# **SEABOARD GROUP II AND THE CITY OF HIGH POINT**

**Re: Five-Year Review Report - Response to Comments  
Former Seaboard Chemical and Riverdale Drive Landfill Site  
Jamestown, Guilford County, North Carolina**

**FIRST FIVE-YEAR REVIEW REPORT**  
**FORMER SEABOARD CHEMICAL CORPORATION FACILITY AND**  
**RIVERDALE DRIVE LANDFILL SITE**  
**JAMESTOWN, NORTH CAROLINA**

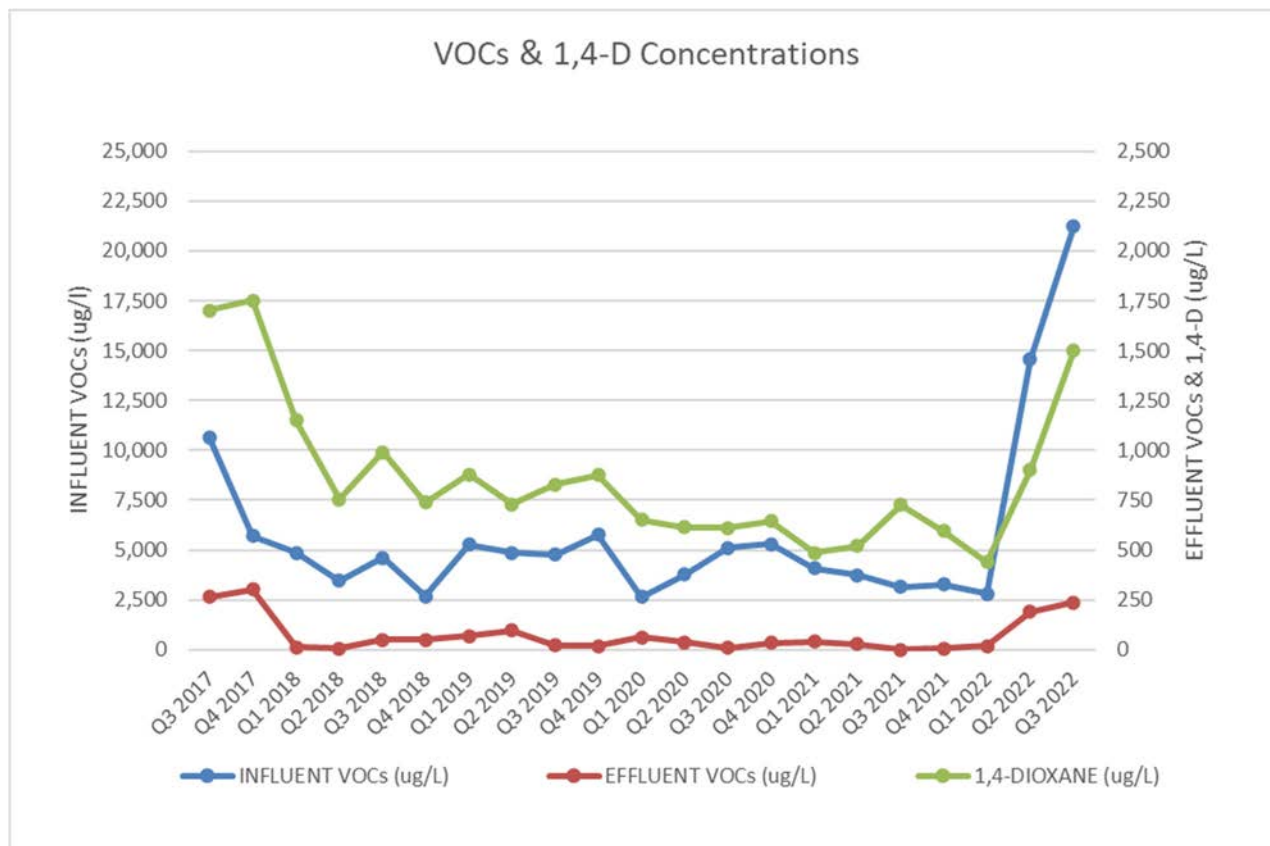
Comment 12: Section IV (Page 21), *Operational Data*. The two Y axes on the graph are confusing, especially because the scales differ so widely. To aid the reader, change the left-hand Y axis title to “Influent, VOCs” and the right-hand Y axis to “Effluent, VOCs”.

Response: Edits have been made to referenced graph and included with the revised Five-Year Review Report.

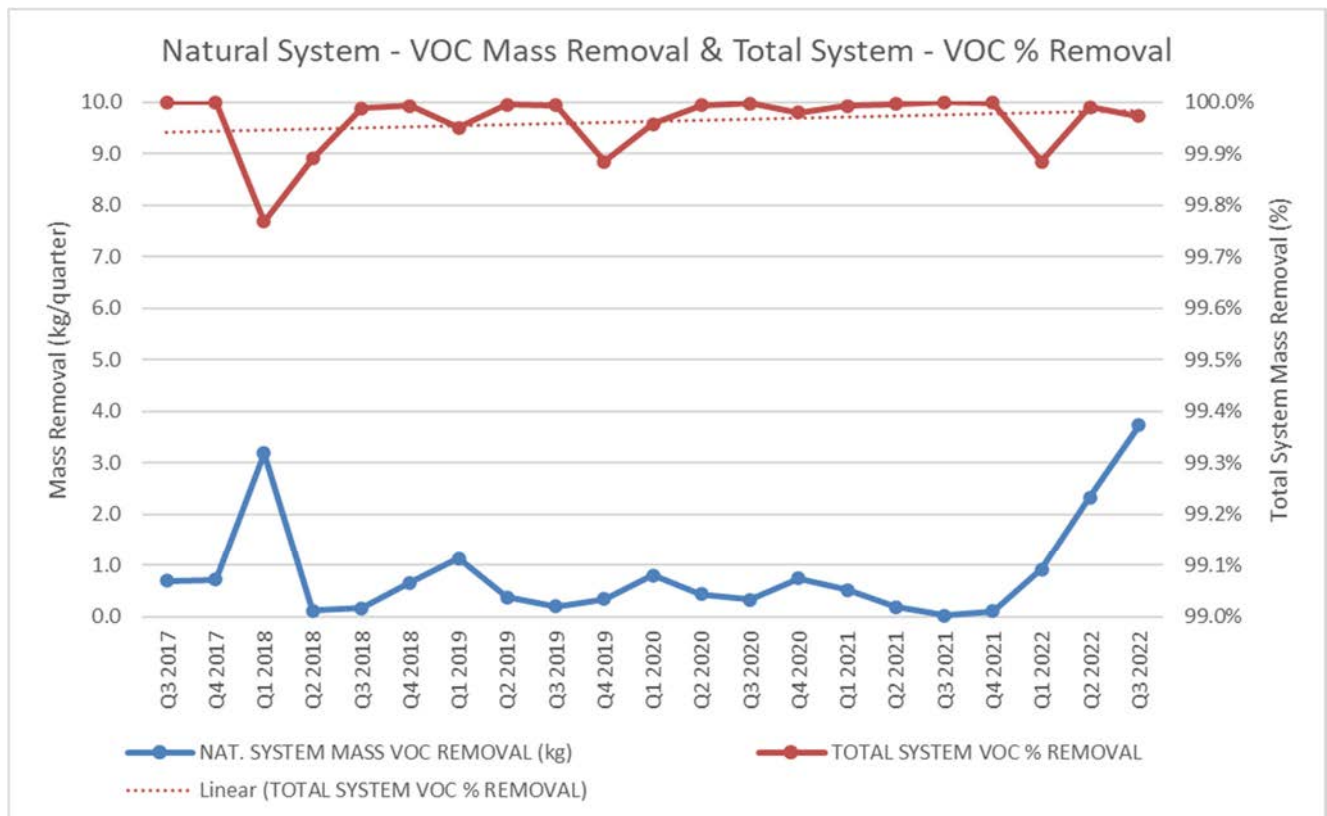
Comment 11: Section IV (Page 19), *Operational Data*. On the Flow Comparison Chart, change the “Phyto Disch” curve legend text to “Discharge to Phyto”. This change will clarify that the curve represents the total discharge of water to the natural (phytoremediation) system.

Response: Edit to referenced chart has been made and included with the revised Five-Year Review Report.
